Subject: STAFF REPORT ADDENDUM for Item W 12a Consistency Determination (CD-057-12, U.S. Army Corps of Engineers, Upper Bluff Vertical Wall, Pismo Beach, San Luis Obispo County)

Consistency Determination No.: **CD-057-12**

Project Description: Construction of upper bluff vertical shotcrete tie-back wall (Exhibits 3-9)

SITE PLAN
SCALE: 1"=20'

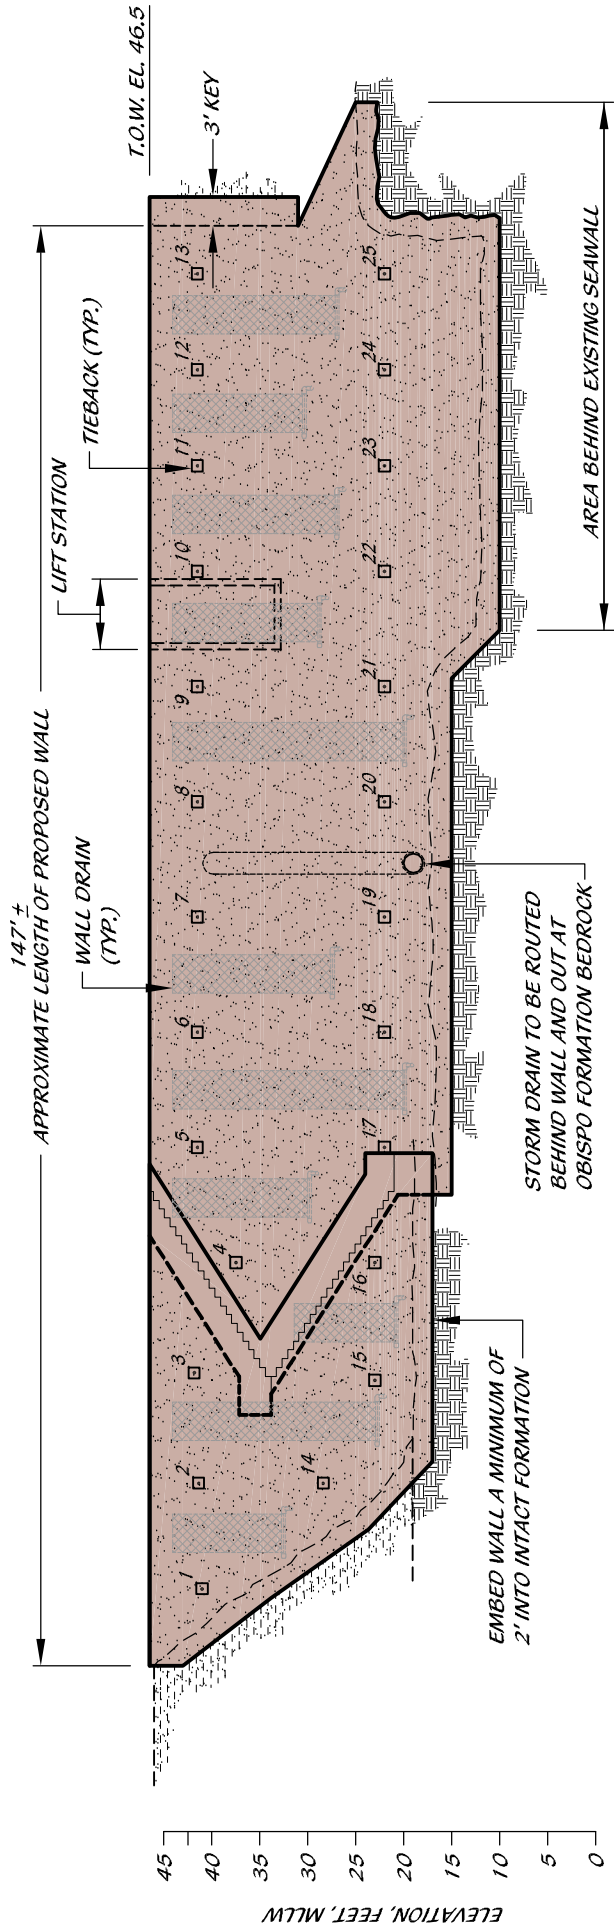
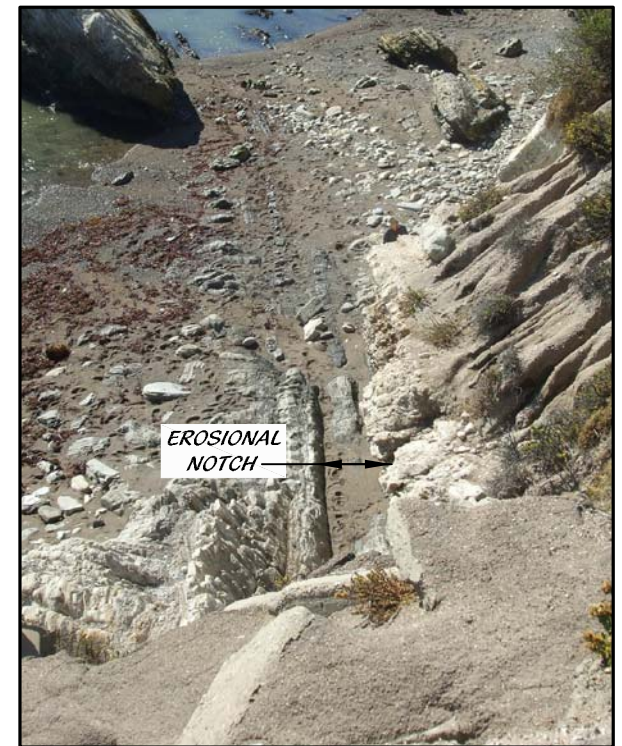
1) It isn't fully clear to us why the Corps states removal of the portion of the wall in front is infeasible (and/or would destabilize the bluff) - we will want that spelled out in greater detail.

3) *It's not clear what happens at the upcoast (west) end of the existing wall (say, half way between cross sections D and E). With the new wall further behind - would the two be joined? I'm not sure how far back the existing wall's endwall goes (as its covered by eroded bluff material) - would it intersect the new wall? Can you provide a cross section for that? (We've never seen any plans for it and it's not clear it ever got any coastal permits.)* As suggested in our responses to Questions 1 and 2, above, the Corps has always assumed that the new proposed wall would be a standalone structure constructed well landward of the existing seawall and well landward of the upcoast (west) end of the seawall. The new wall has been designed with no reliance on the existing wall and, as importantly, to continue to fully function and maintain its aesthetic character even if the existing wall were to fail and eventually be removed. Under no circumstances would the new wall be incorporated into the existing wall. While the Corps also is unsure of how far back the existing wall's upcoast return goes, the new wall has been designed as if the existing wall does not exist, and in fact its' construction is predicated on the new construction-period bluff face graded back to that shown on the Corps' Plan and Profile, assumed to be sufficiently landward of the existing wall to facilitate the safe construction of the new wall along its entire alignment, including that area behind the existing wall.
